UNITED STATES PATENT AND TRADEMARK OFFICE

APPLICATION NO.	FILING DATE	FIRST NAMED INVENTOR	ATTORNEY DOCKET NO.	CONFIRMATION NO.
10/516,331	11/30/2004	Wan Shik Chae	31758-210506	3046
26694	7590	10/27/2006	EXAMINER	
VENABLE LLP P.O. BOX 34385 WASHINGTON, DC 20043-9998			CAJILIG, CHRISTINE T	
			ART UNIT	PAPER NUMBER
			3637

Office Action Summary

DETAILED ACTION

Gronau et al. (U.S. Patent No. 4,856,250)

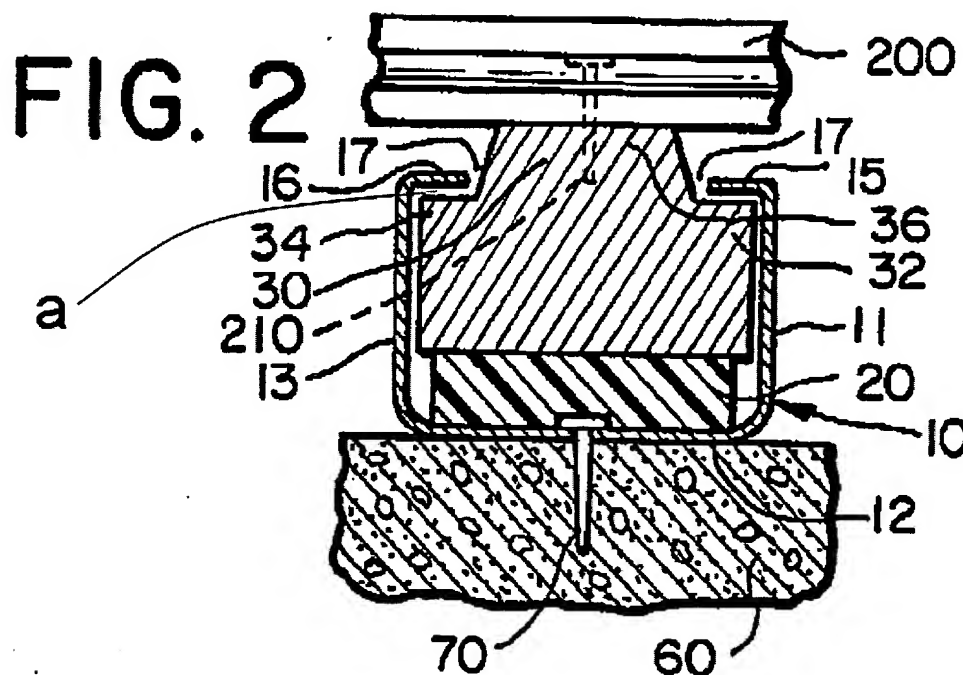
However, Gronau et al. in Figure 2 discloses a long shaped rail (10) with a lower surface (12), which is placed on an attachment surface (60) for attaching a panel (200), an upper surface (15) on which the panel (200) is mounted, and a guide groove (a) in the longitudinal direction (the direction parallel to and along the side walls 11 and 13 of the rail 10) wherein an attachment panel (30) is guided in the guide groove (a) and installed movably in the longitudinal direction of the rail (10). Chiu-Ying '522 and Gronau et al. are analogous because both are in the same field of endeavor of floor systems. Therefore, it would have been obvious for a person having ordinary skill in the arts at the time of the Applicant's invention to modify the floor assembly of Chiu-Ying '522 to include a long shaped rail with a lower surface, which is placed on an attachment surface for attaching a panel, an upper surface on which the panel is mounted, and a guide groove in the longitudinal direction wherein an attachment panel is guided in the guide groove and installed movably in the longitudinal direction of the

rail as taught by Gronau et al. to provide a guide way to allow an attachment panel to move in response to dimensional changes in the flooring material (Col 2, Ln 36-41).
